**CTC-18-205    BLAXCELL STREET & FARNELL STREET, GRANVILLE – PROPOSED  
PEDESTRIAN FENCING AT THE ROUNDABOUT**

State Electorate: Granville                      PAC: Cumberland  
(File No. T-28-01/06)

**TITLE:** Proposed Pedestrian Fence in Blaxcell  
Street & Farnell Street, Granville

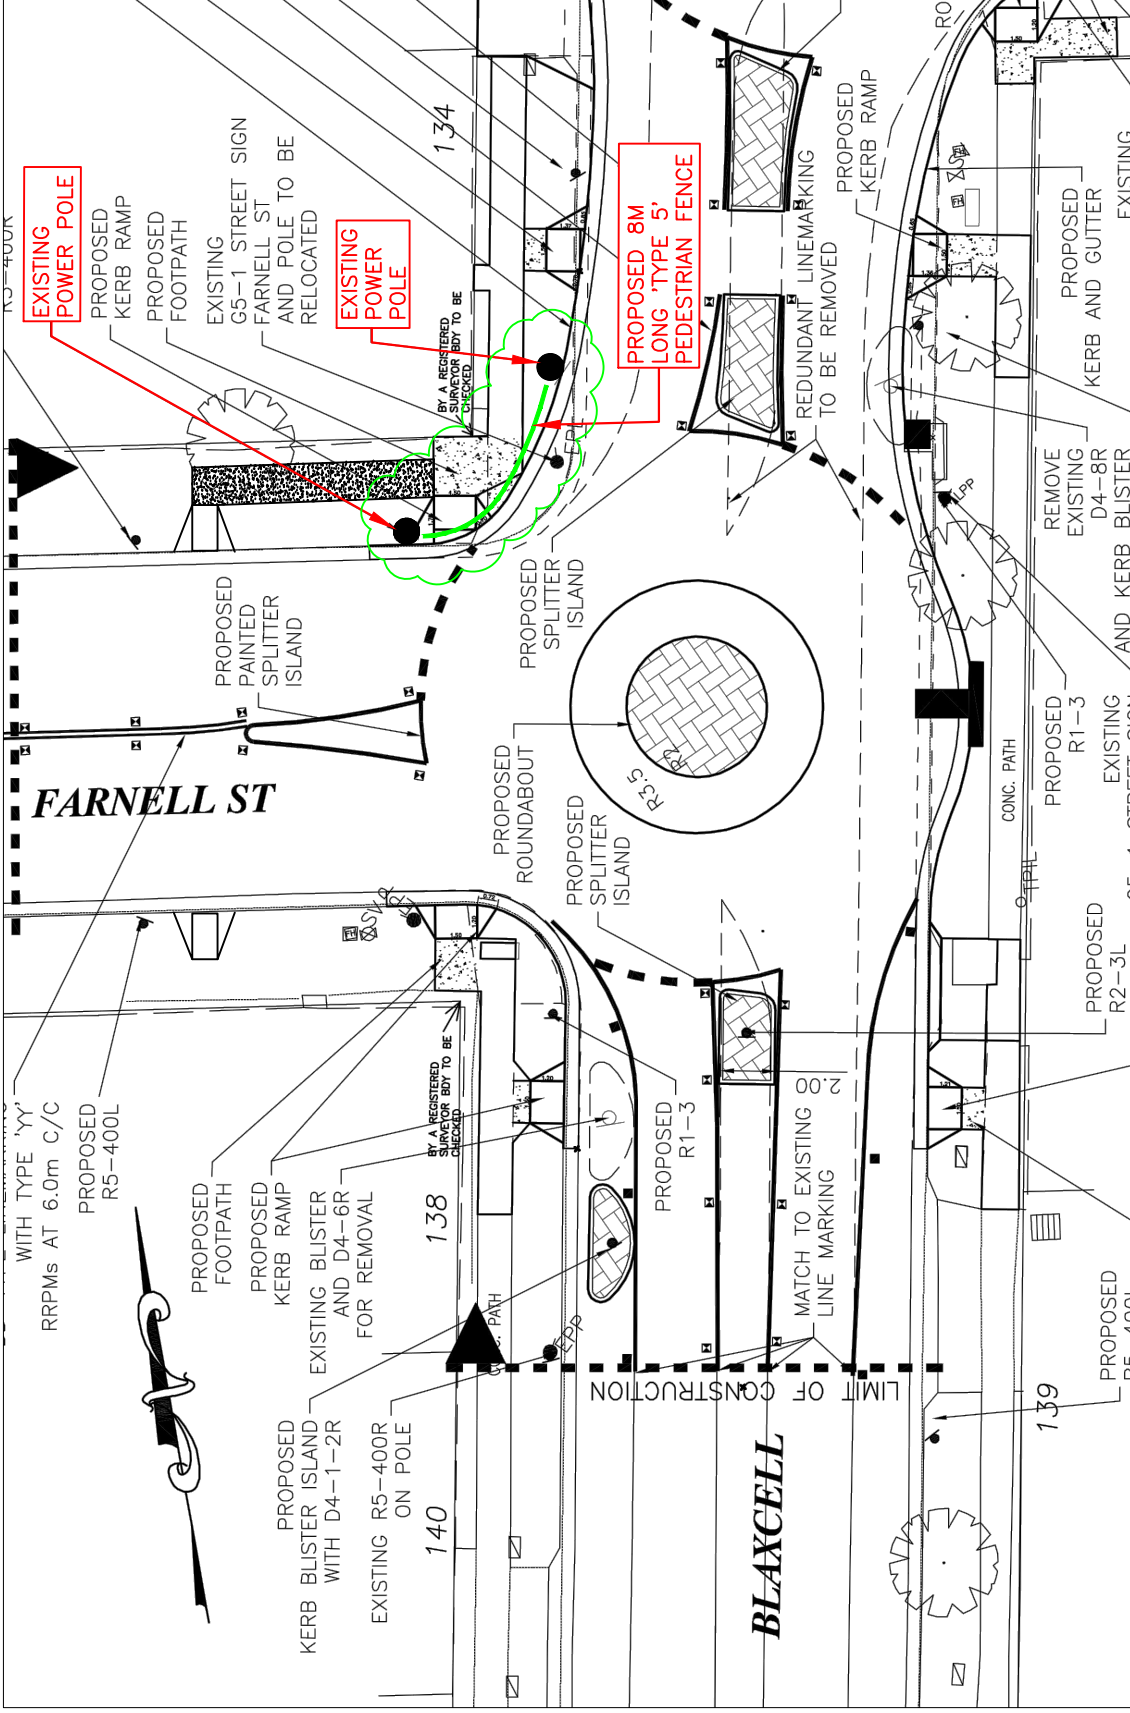
The RMS representative stated that a pedestrian fence in this location will have more impact on pedestrians and should not be installed.

Traffic committee members agreed with the representative.

The Cumberland Traffic Committee recommended that the installation of pedestrian fencing on Blaxcell Street and Farnell Street, Granville not be approved.
